Millway Beach

ADA Transition Plan

July 2021

Institute for Human Centered Design

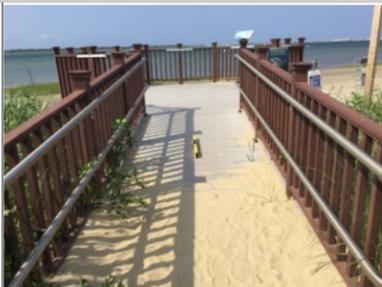
- Accessible routes are not maintained in operable working condition.

Note: Millway Beach is not accessible. The topography of the beach prevents the possibility of having an accessible route.
